Consultation Response from Alan Smith, KC Waste Strategy(Refuse & Recycling)
2025/91370 Land at, Gynn Lane, Honley, Holmfirth, HD9 6LF
Demolition of existing dwelling and erection of 50 dwellings with associated access, infrastructure and associated works
Date Responded: 01/07/2025 Responding Officer: Alan Smith Responding Ref: WPS 25 018

The applicant has submitted Planning layout "Proposed Site / Block Layout [id 1091727] Size: 9.9MB 11/06/2025 - 2479-0301-R13 - Site layout."

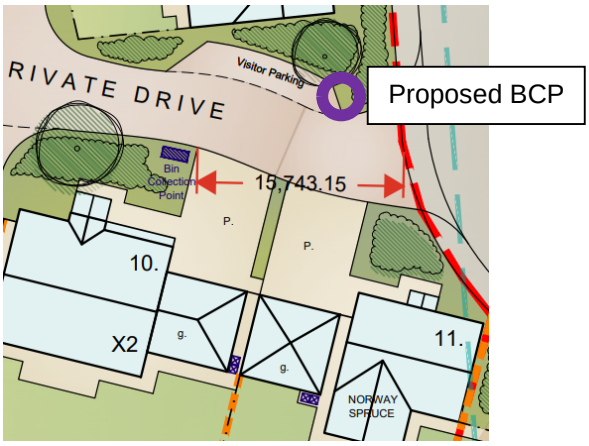
- Plots 9, 10 and 11 have a shared BCP outside plot 10. The proposed BCP is 15m from the main road nearly more than double the recommended 8m. Ideally a new BCP is installed at the right-hand side of the visitor car park opposite plot 11, as indicated on the plan below.
